Subject: Finding of No Significant Impact for Kokokahi Place Drainage
Improvements, TMK: 4-4, Kaneohe, Oahu, Hawaii

**Final
Environmental Assessment**

**KOKOKAHI PLACE
DRAINAGE IMPROVEMENTS
KANEOHE, OAHU**

PROPOSED DRAINLINE ALIGNMENT FROM KOKOKAHI PLACE

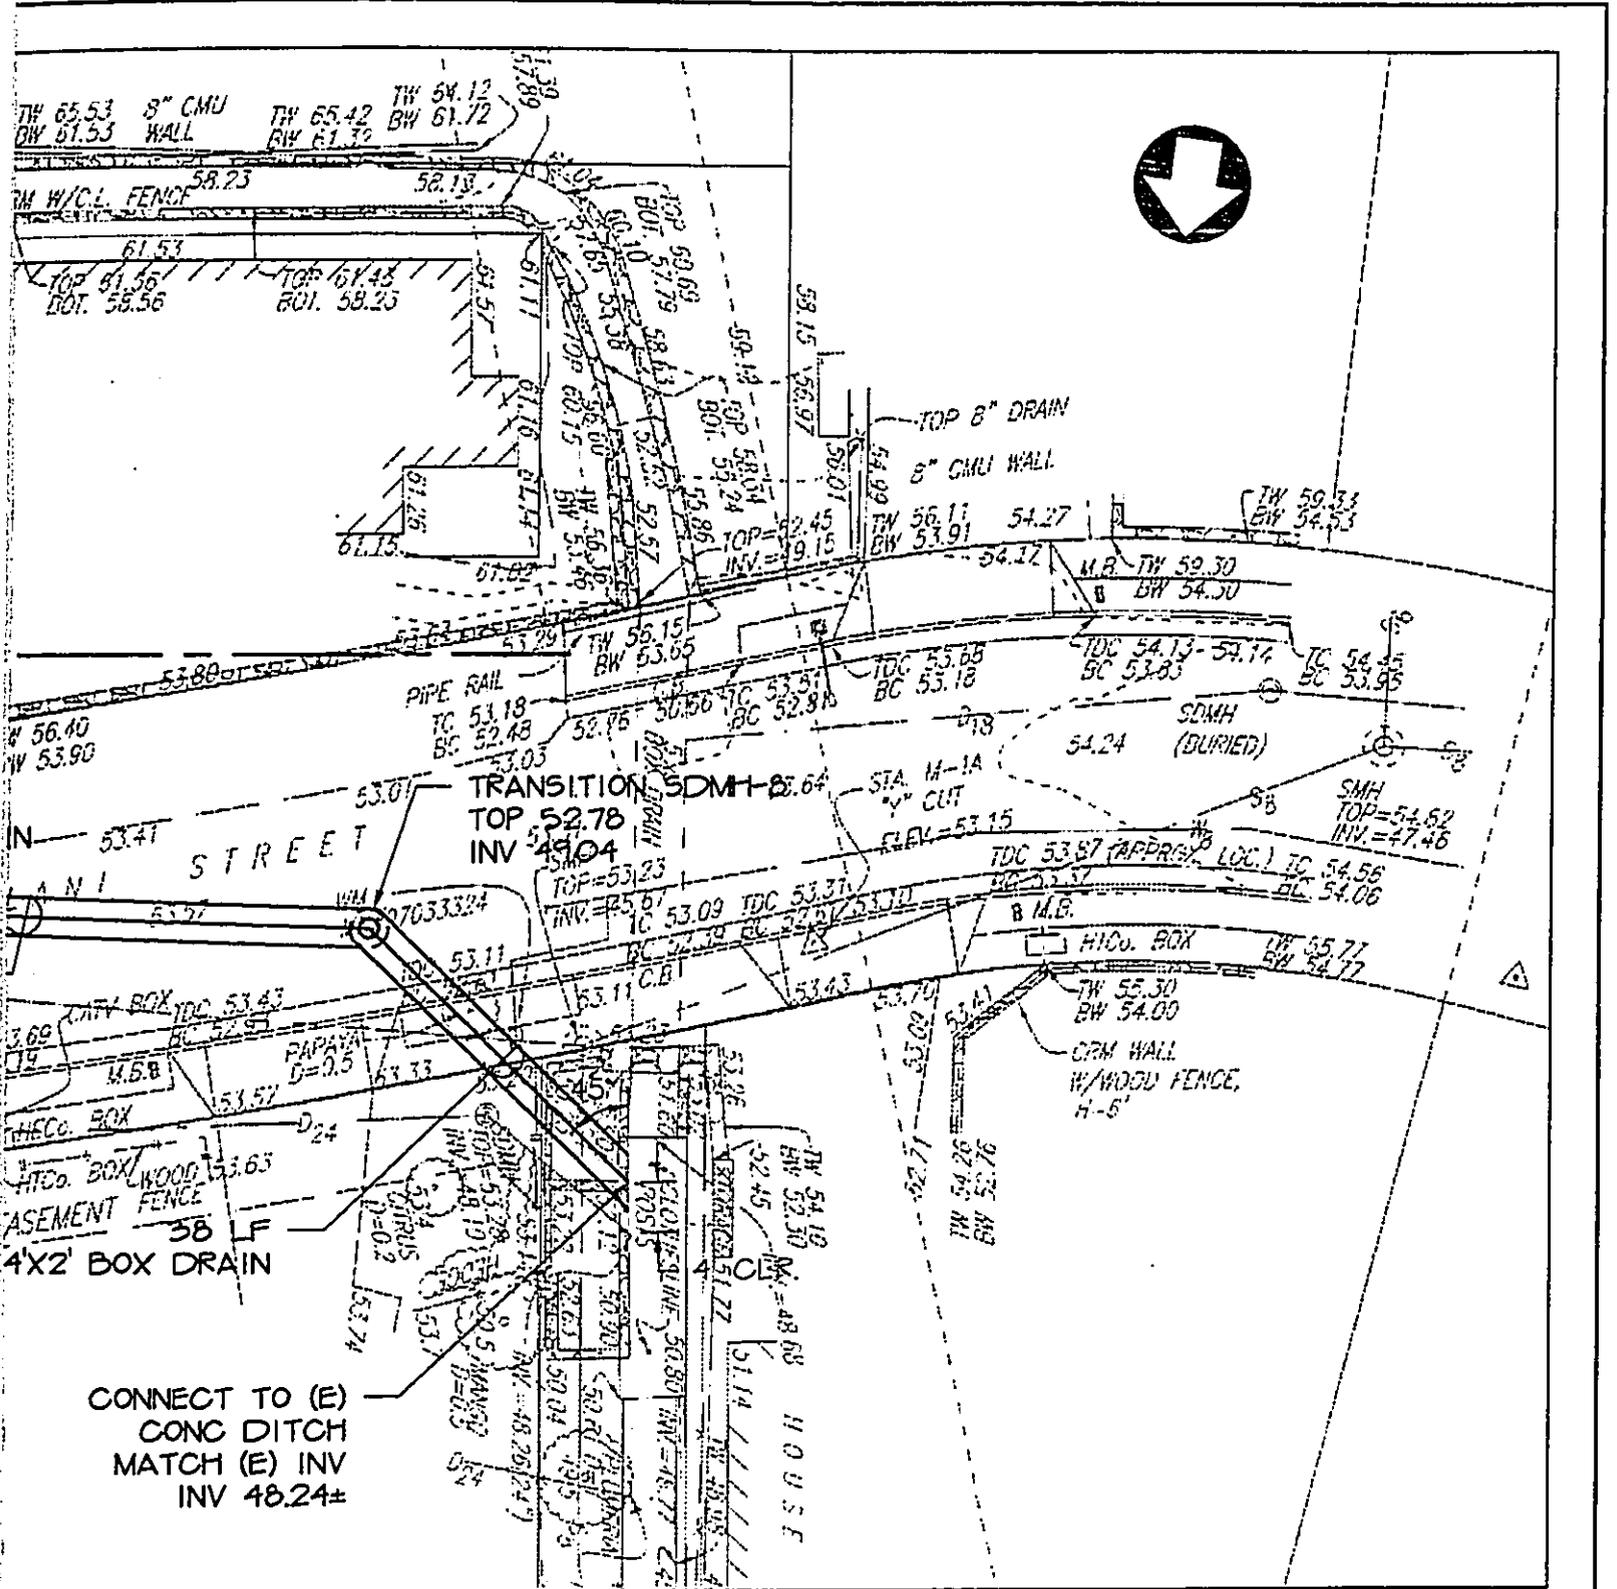
In reviewing Figure 7, it is also difficult to understand how the proposed drainage easement may impact existing structures in its immediate vicinity. For example, the proposed easement appears to include most of an existing CMU wall that forms the western property boundary of parcel 118. Will the proposed project require either partial or total removal of the wall? If removed, will it be replaced? There is an existing utility pole identified in the area immediately fronting the stand-alone garage on parcel 85. Based upon the scale of Figure 7, it appears that the utility pole is approximately 2.5 feet from the centerline of the proposed 24-inch pipe. Will excavation for the drainage line require temporary removal of the utility pole? How will the pole be impacted by construction? How will electricity, telephone, and cable TV service be provided to the properties that rely upon this utility pole, should it be impacted by construction activities?

Figure 7 presents the plan for the middle section of the new drain line. To maintain a horizontal clearance from the existing 8-inch sewer line running along the easement, the new drain line must be located outside the existing easement boundaries, and new easements obtained. The installation of Drain Inlets 4 and 5 has been proposed in the flat areas along the private driveway to collect the flow coming from areas below the cul-de-sac. These inlets will lessen the amount of drainage flowing into the private ditch rounding the property located at 45-024 Malulani Street. Approximately halfway up the private driveway, there is an existing ditch that crosses beneath the roadway. The proposed drainage line will run underneath the existing ditch. The actual methods of construction have not yet been determined, but the flow within the ditch will not be affected.

FIGURE 10

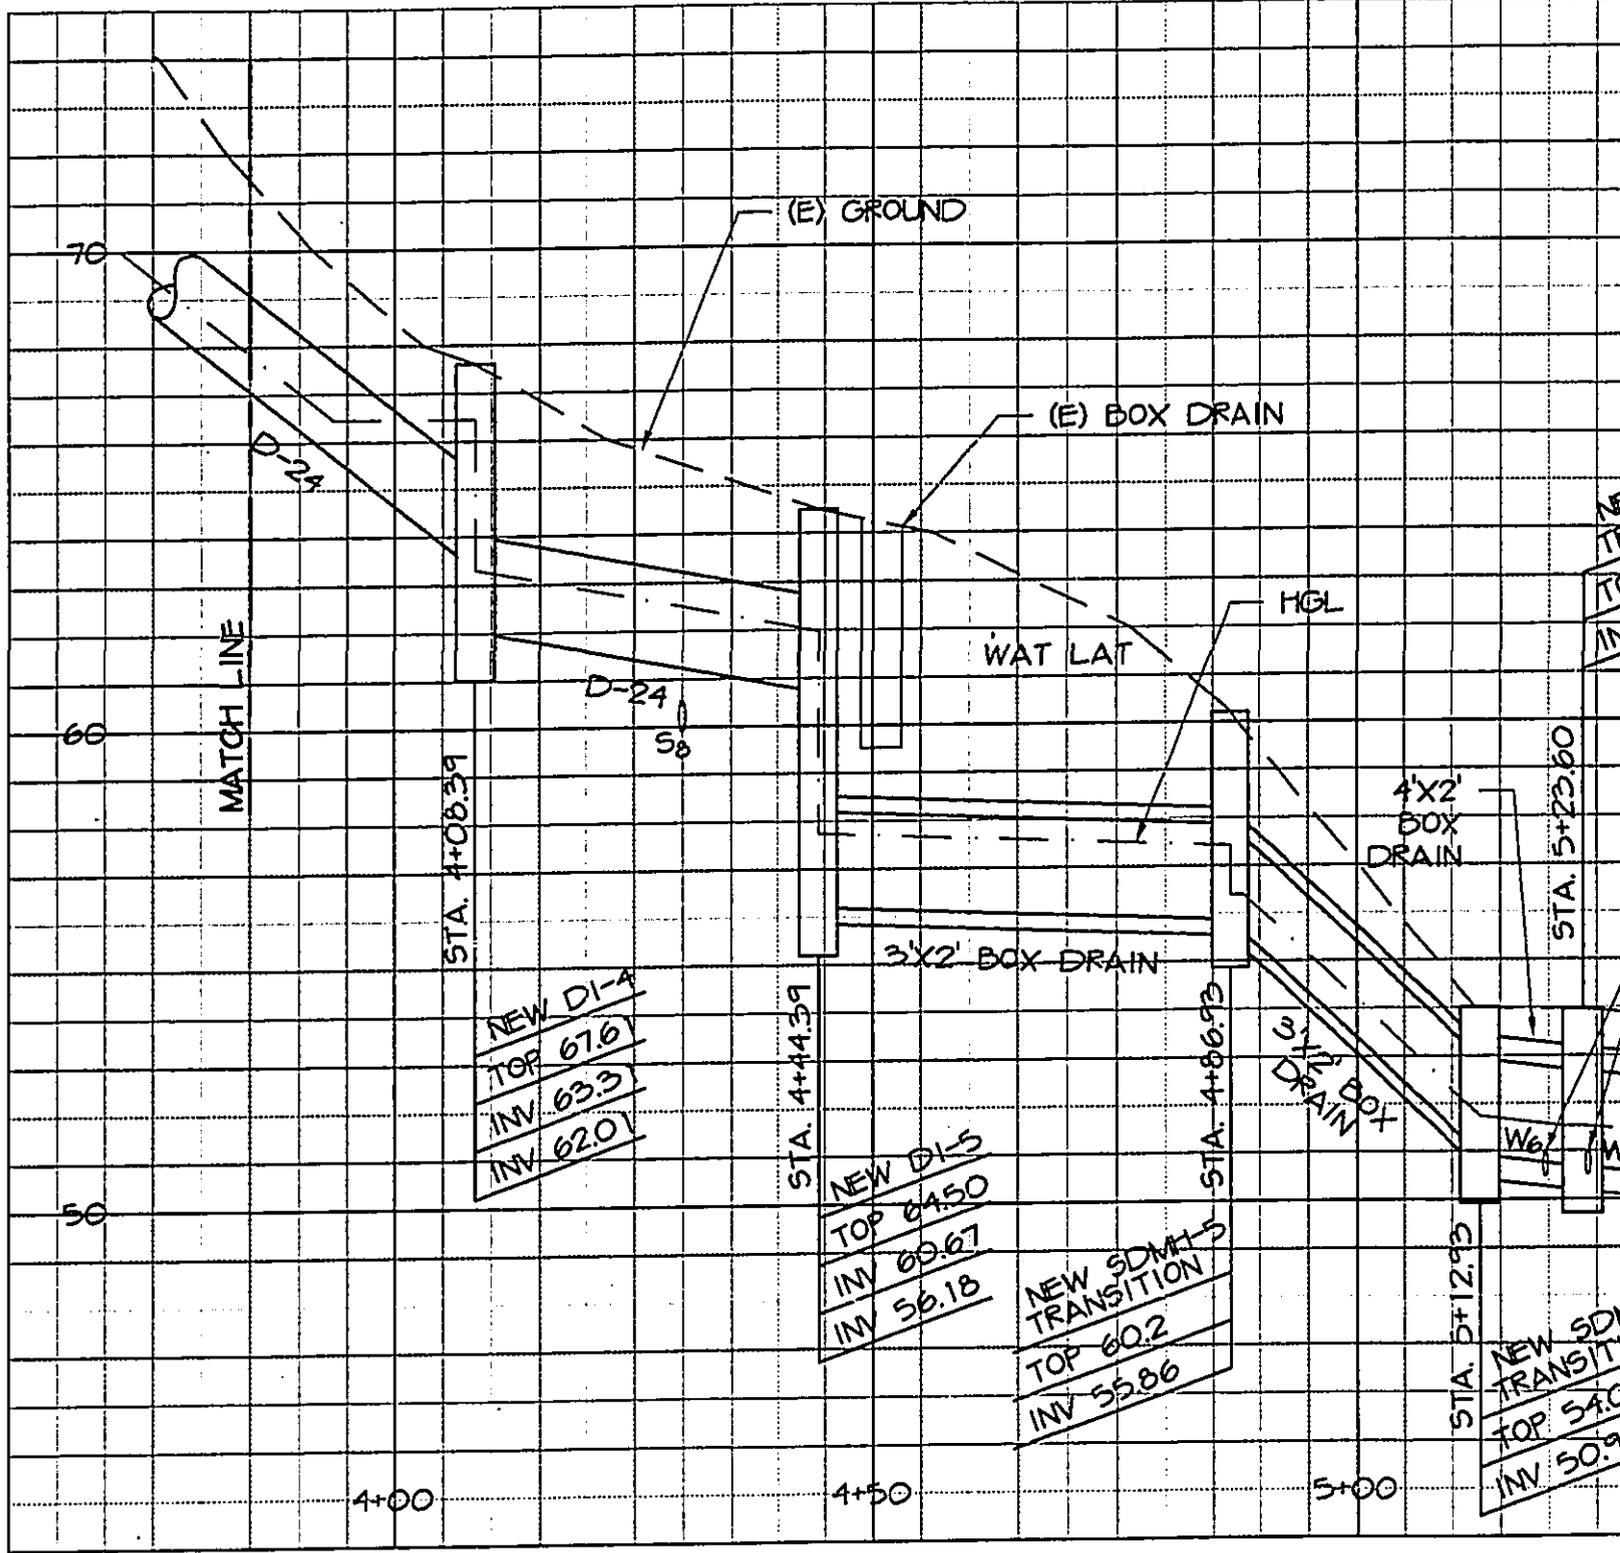
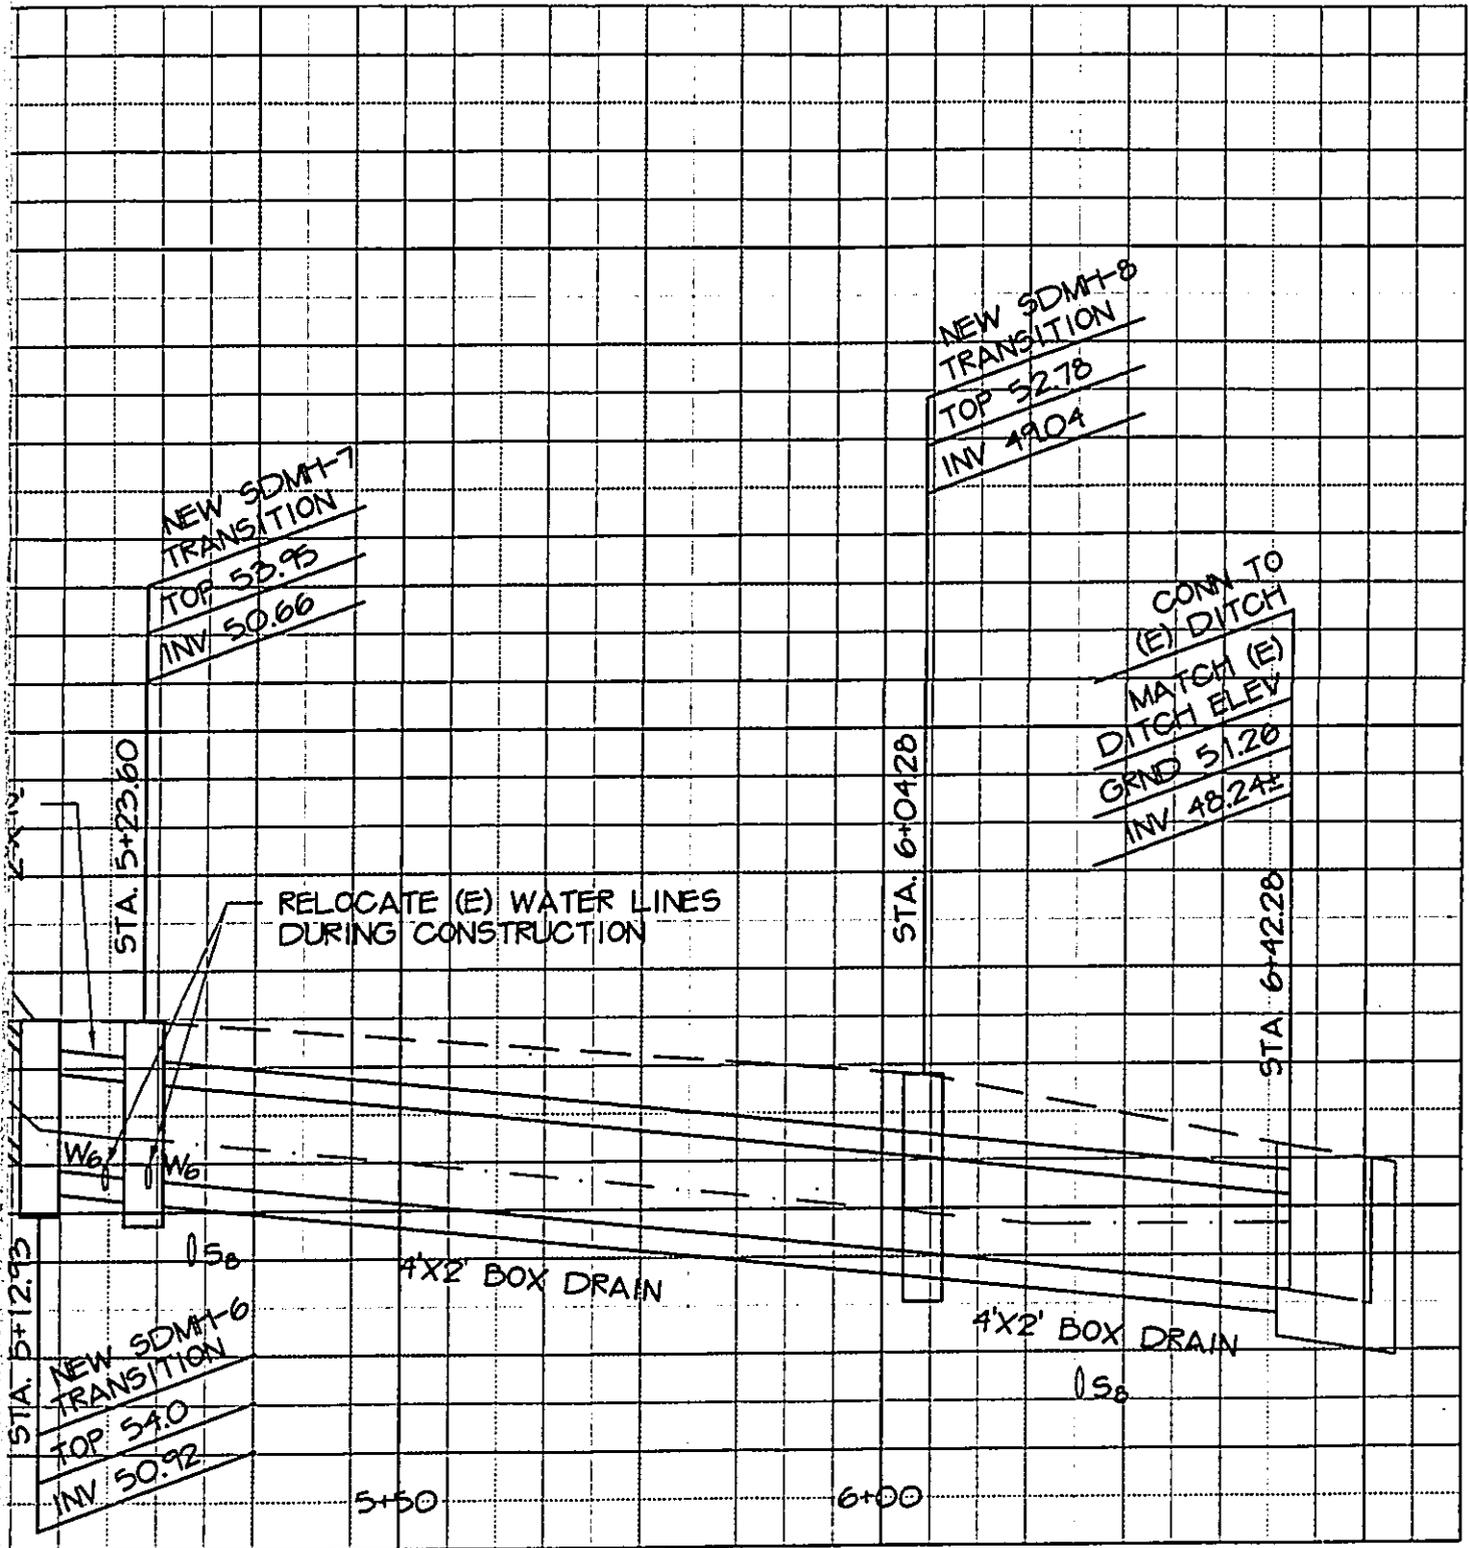
I cannot determine if Figures 10 and 11 in the Draft EA adequately address the physical character of the location where the private ditch and parcel 105 intersect. However, it appears to me that the Draft EA does not consider the fact that the intersection of the private drive and the private ditch consists of a concrete slab across the open ditch. In other words, the entire width of parcel 105 at the point where it intersects the ditch is actually a bridge. Please address the following questions in the EA. Will the drainage line proposed to be constructed within parcel 105 extend beneath (under) the bottom of the existing ditch or through it? If the drainage line extends through the ditch walls under the bridge, won't that create an obstacle to water flowing into the ditch from the underground drainage pipe that feeds it, resulting in potential flooding, not to mention potential damage to the bridge by water undermining it from beneath if obstructed by the drainage pipe and forced upward? Please discuss in the EA how drainage into and through the private ditch will be impacted by the excavation of the trench for the drainage line and installation of the drainage line and box drain in proximity to the ditch.

Figure 11 shows that the drain line will go beneath the existing ditch. We have not determined at this time how construction will take place, but whatever is decided should not affect the flow within the ditch. Should the Contractor elect to remove the existing box drain to facilitate construction, it will be reconstructed.
